Service Bulletin

Bulletin No.: 23-NA-205

Subject: Audio Boom or Drone Noise Caused by Active Noise Cancellation with RPO UQS

| Brand: | Model: | Model Year: | | VIN: | | Engine: | Transmission: |
|-----------|-------------------|-------------|------|------|----|------------|---------------|
| Chevrolet | Corvette Stingray | 2024 | 2024 | — | — | 6.2L (LT2) | — |

Figure 1: T3 Amplifier Connector X2 (1)

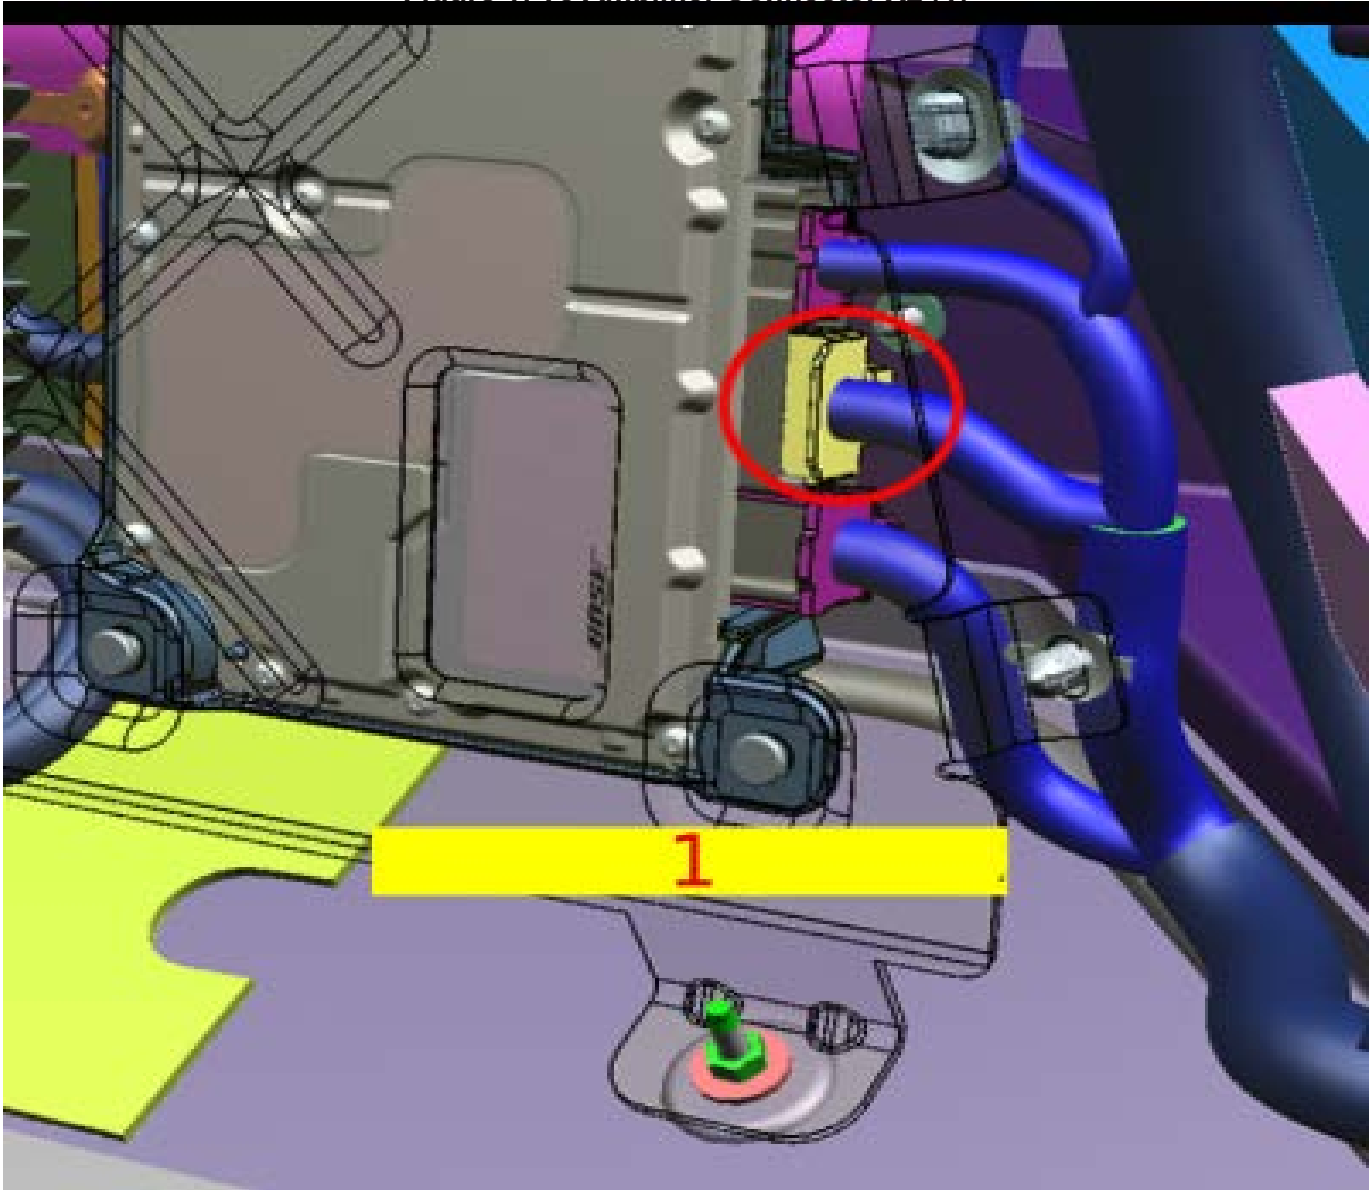
1. Follow SI for *Vehicle Performance Data Recorder Bracket Replacement* (Doc ID 5388184) to remove the bracket covering the T3 radio speaker amplifier in the passenger footwell.
2. Remove connector X2; location shown in Figure 1.

Figure 2: T3 Connector X2 (in the as-built condition)

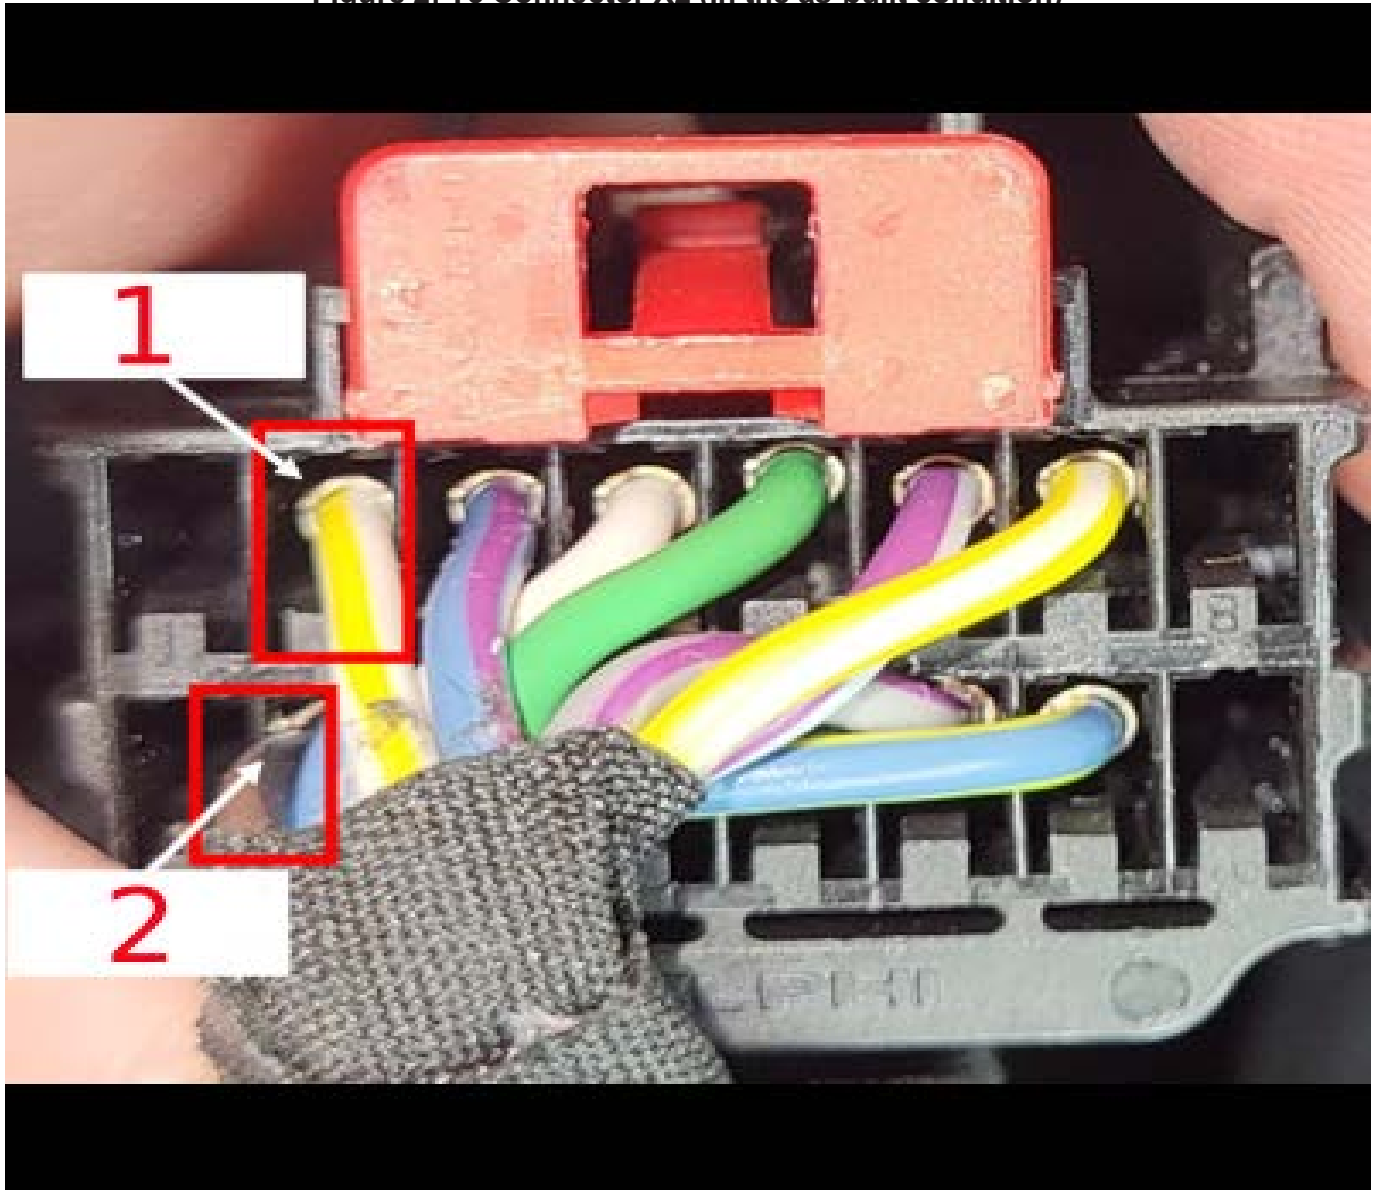
| Cause | The cause of the condition may be that the wiring harness may have a different polarity than the amplifier for the right front midrange speaker. |

3. Locate terminals two (1) and ten (2) in the X2 connector, as shown in Figure 2.

4. Use terminal removal tool J-38125-215A to swap terminals 2 and 10 such that the brown with black stripe wire will be in the upper cavity 2, and the white with yellow stripe wire will be in the lower cavity 10. Use SI Doc ID 6422077 if needed for connector reference information.
